B.M. ELEV.	FIELD BOOK #:	UMA AECOM	
POSTED TO LBIS		DESIGNED BY: BM/LK	CHECKED BY: -----
		DRAWN BY: SCK	APPROVED BY: --
E ISSUED FOR ADDENDUM 3	08/01/23	QL	
D ISSUED FOR BID	07/12/14	LJV	
C ISSUED FOR 100% REVIEW	07/11/09	SCK	
B ISSUED FOR ZONING	07/08/21	SCK	
A ISSUED FOR 80% REVIEW	07/06/18	SCK	
NO. REVISIONS	DATE	BY	FILENAME: D265-202-02_E-0401_RX.dwg

THE CITY OF WINNIPEG
 WATER AND WASTE DEPARTMENT
PERIMETER ROAD PUMPING STATION UPGRADES
 Contract B - Building Upgrades
 Electrical - Lighting Layout
 LEVEL 400 FLOOR PLAN
 CITY DRAWING NUMBER: **1-01111L-E0010** SHEET: **001** REV: **E** SIZE: **D**

PLAN LEVEL 400

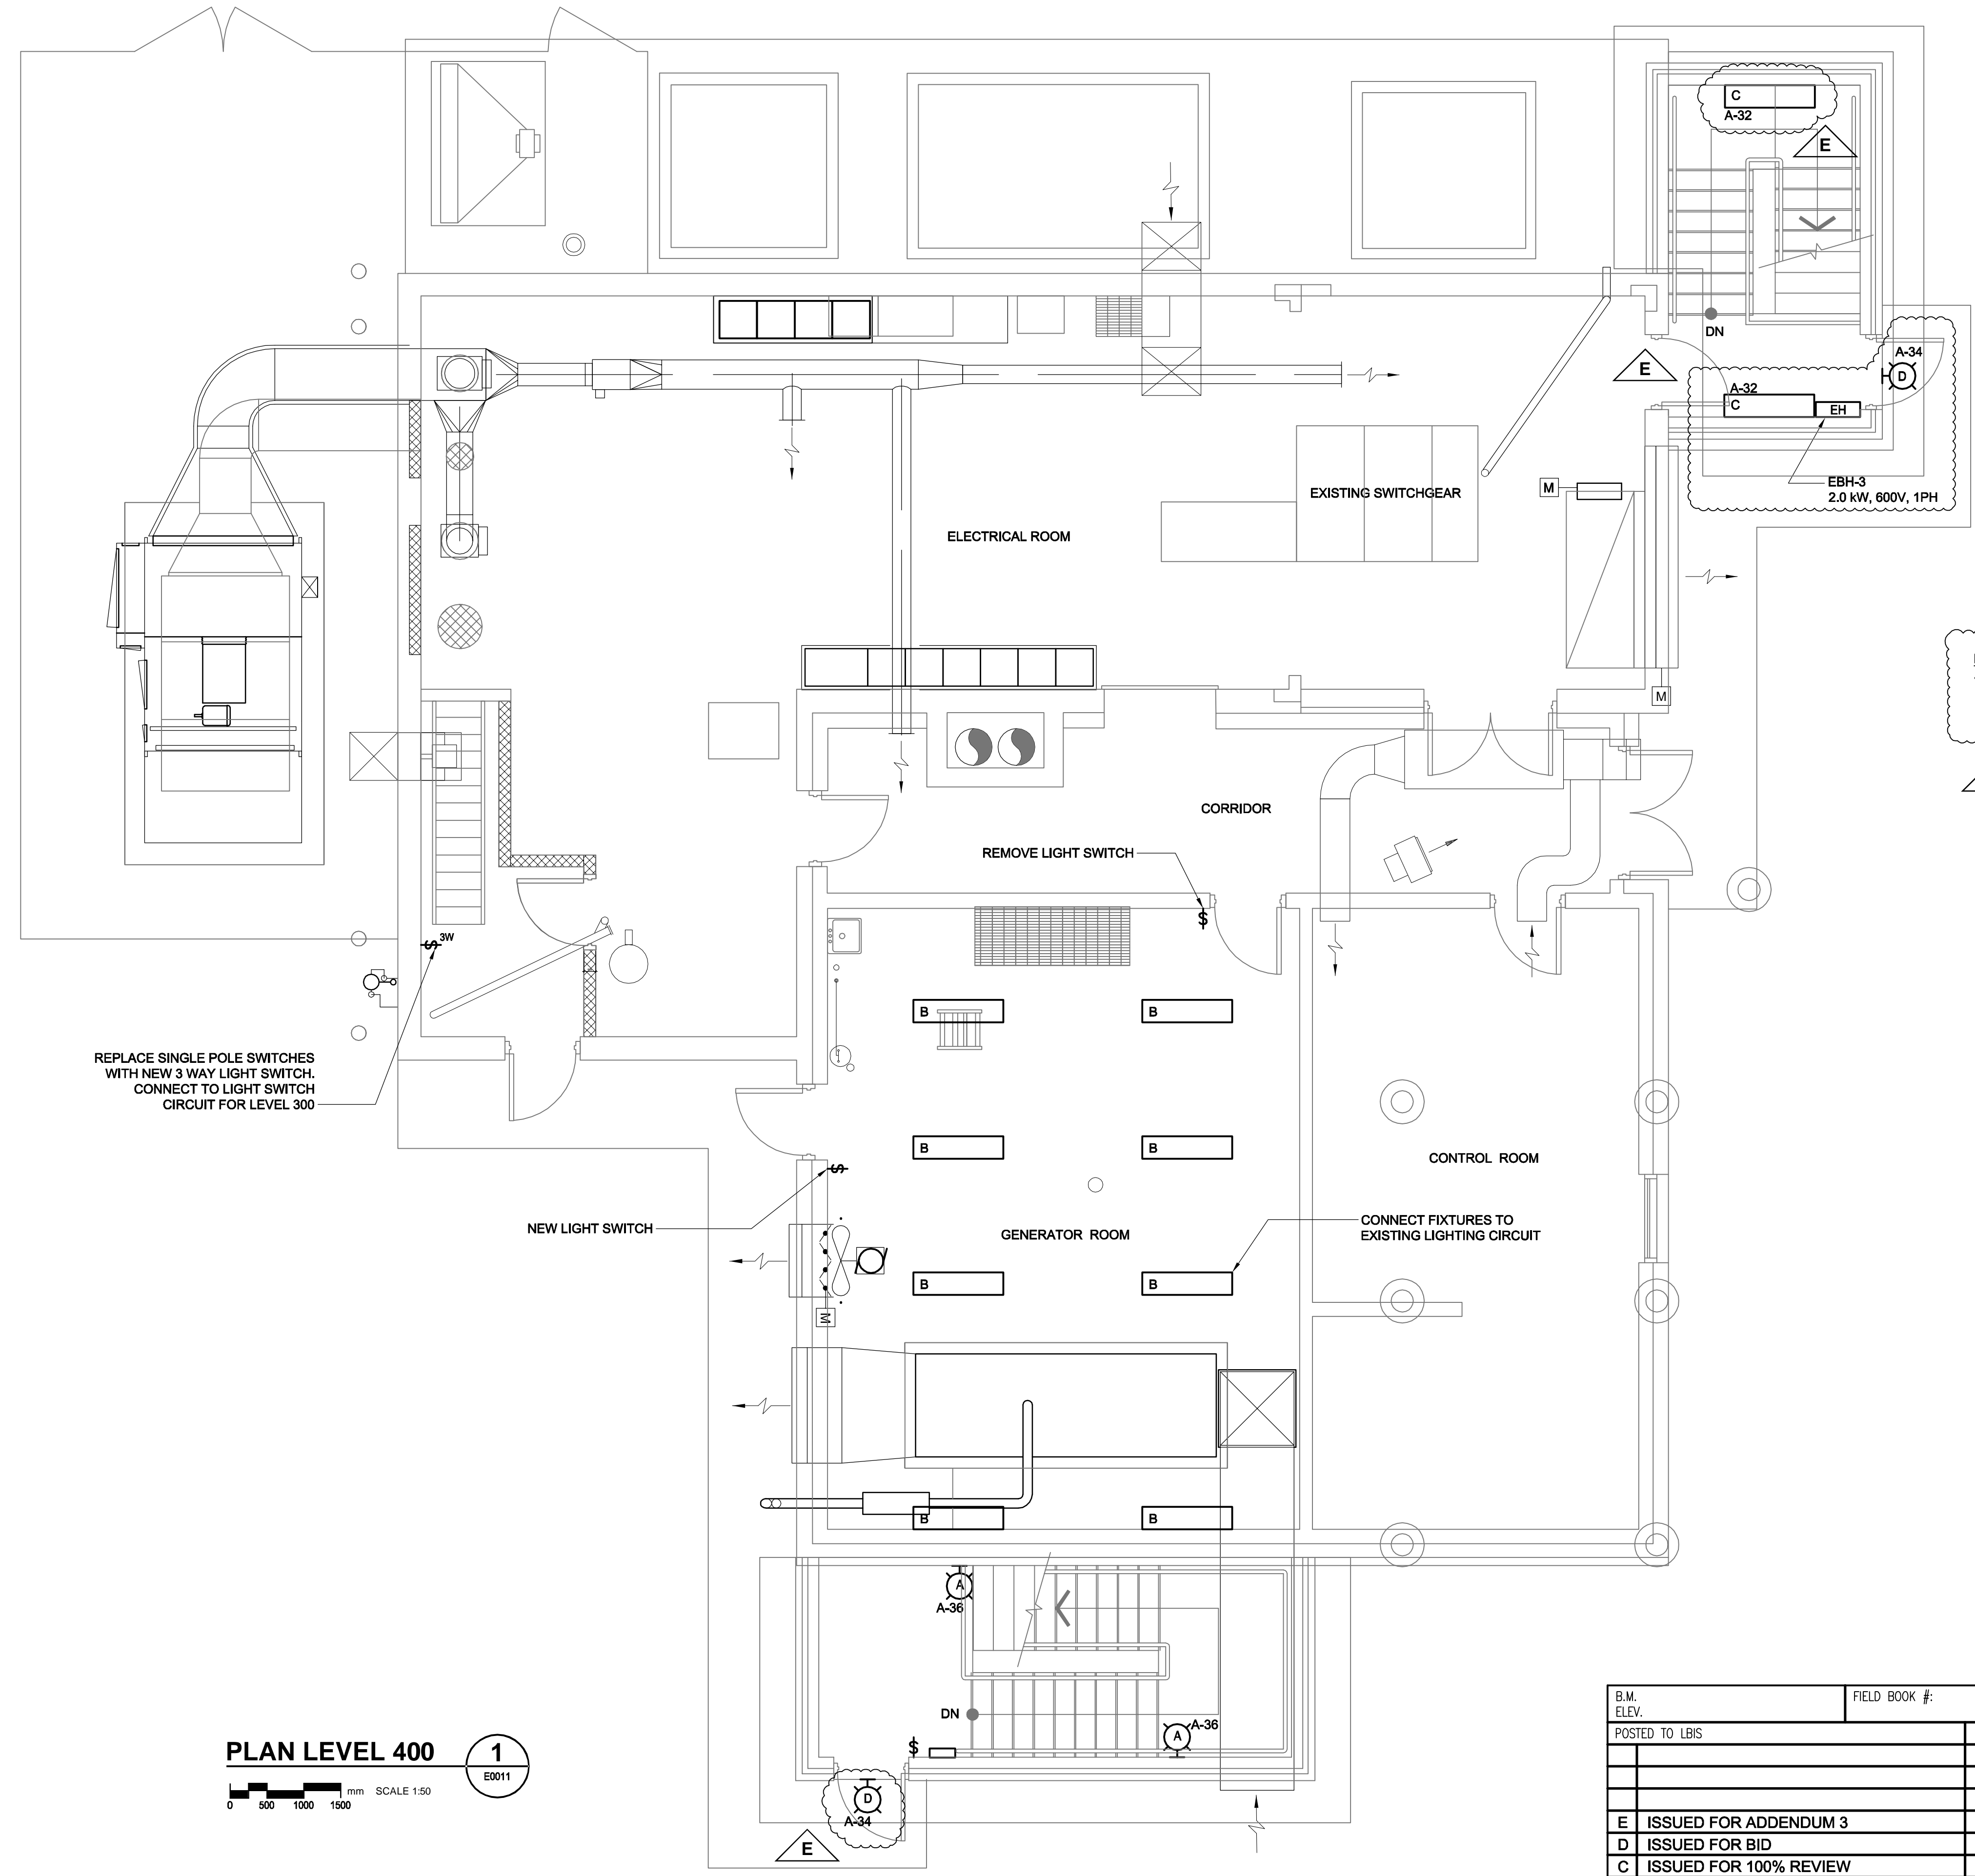
REPLACE SINGLE POLE SWITCHES WITH NEW 3 WAY LIGHT SWITCH. CONNECT TO LIGHT SWITCH CIRCUIT FOR LEVEL 300

CONNECT FIXTURES TO EXISTING LIGHTING CIRCUIT
